GNRO-2012/00001

SUBJECT: License Amendment Request - Standby Liquid Control System

Grand Gulf Nuclear Station, Unit 1  
Docket No. 50-416  
License No. NPF-29

**Proposed Technical Specification Changes (Mark-up)**

~~FIGURE 3.1.7-1~~  
~~SODIUM PENTABORATE SOLUTION CONCENTRATION/AVAILABLE VOLUME REQUIREMENTS~~

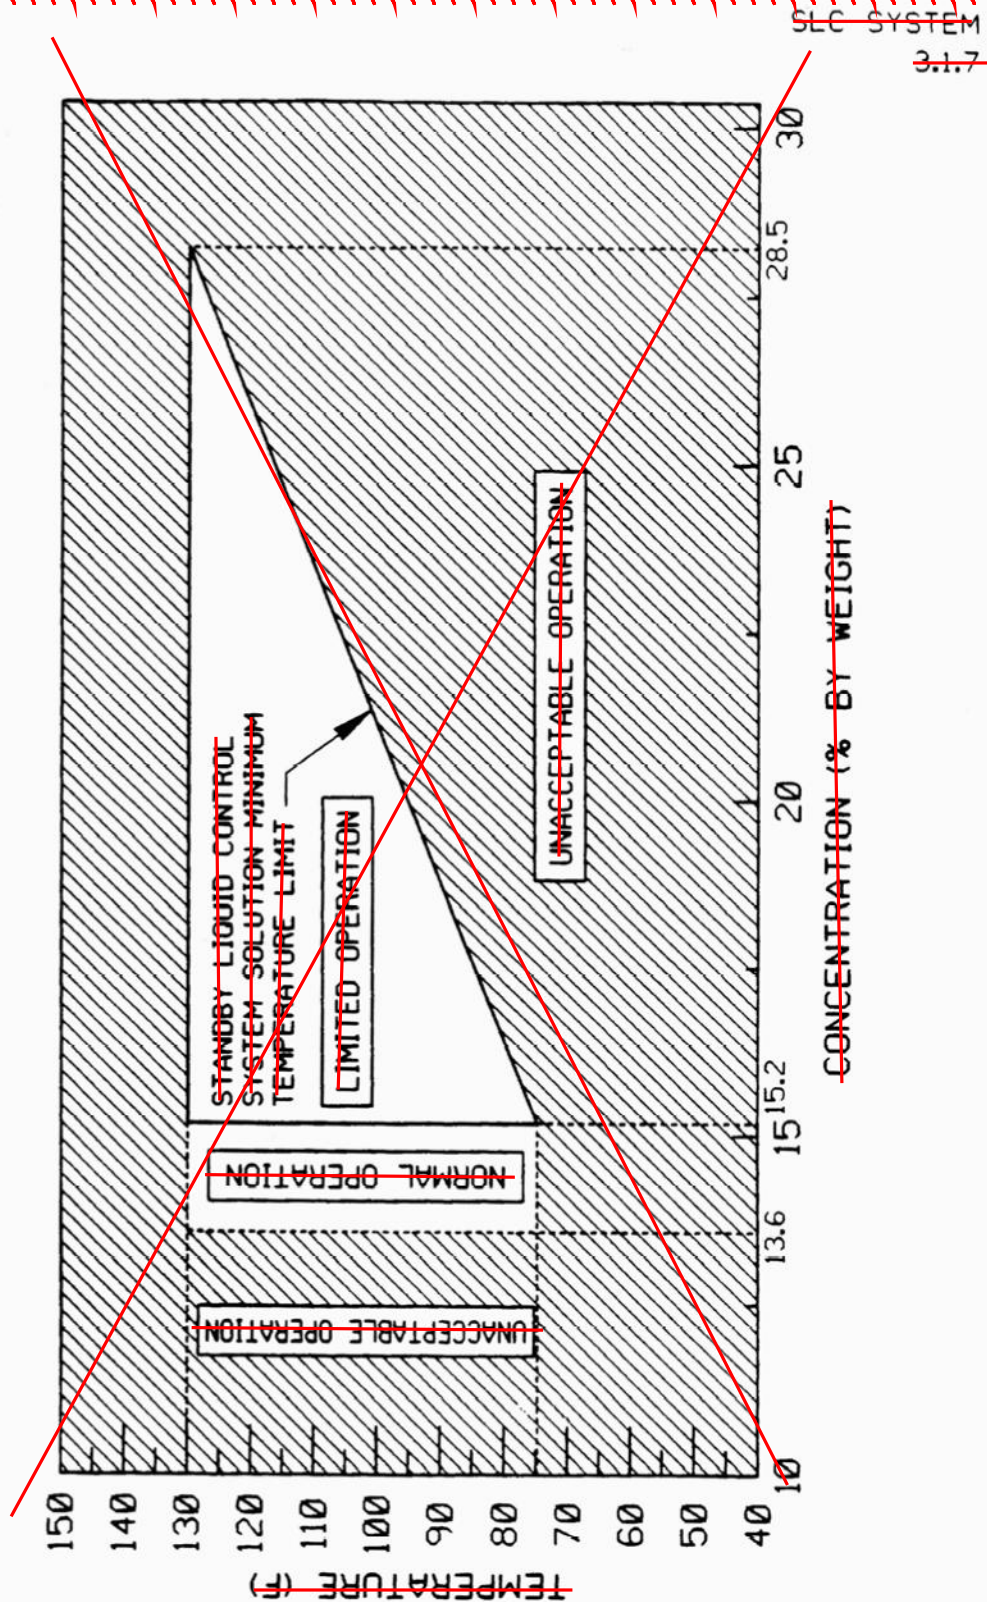
- SR 3.1.7.1 is being revised to verify the available volume of the SPB solution is greater than or equal to 4,200 gallons. This change eliminates the reference to Figure 3.1.7-1.

- SR 3.1.7.2 is being revised to verify the temperature of the SPB solution is greater than or equal to 45°F and less than or equal to 150°F. This change eliminates the reference to Figure 3.1.7-2.

With the proposed revisions described above, Figures 3.1.7-1 and 3.1.7-2 are no longer needed and are proposed for deletion. A note will be added to page 3.1-23 stating that the next page is 3.1-26. This is an administrative change that allows the current TS page numbering to remain the same.
